PCN #: 2564

PCN Title: Additional Wafer Source and Alternate Assembly Lead Frame and Clip Bond for Select Discrete Products

PRODUCT CHANGE NOTICE**PCN-2564 REV1**

Table 2 – Part Marking Format Changes

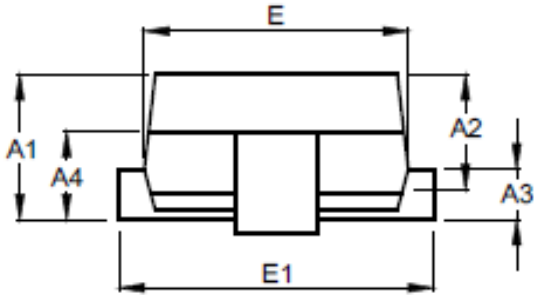
DM8WxxA(Q) marking example (Before)	DM8WxxA(Q) marking example (After)
<p>Marking format example</p> <div style="text-align: center; margin: 10px 0;"> </div> <p>M8WxxA = Product Type Marking Code (i.e. M8W18A for DM8W18AQ-13) DII = Manufacturers Code Marking YWW = Date Code Marking Y = Last Digit of Year (ex: 0 for 2020) WW = Week Code (01 to 53) Bar Denotes Cathode Pin, Circle Denotes Anode</p>	<p>Marking format example</p> <div style="text-align: center; margin: 10px 0;"> </div> <p>M8WxxA = Product Type Marking Code (i.e. M8W18A for DM8W18AQ-13) DII = Manufacturers Code Marking aa: Wafer source code y: Year (L=2021) m: Month (1 – C) d: Date (1 – V) cc: Lot serial number Bar Denotes Cathode Pin, Circle Denotes Anode</p>
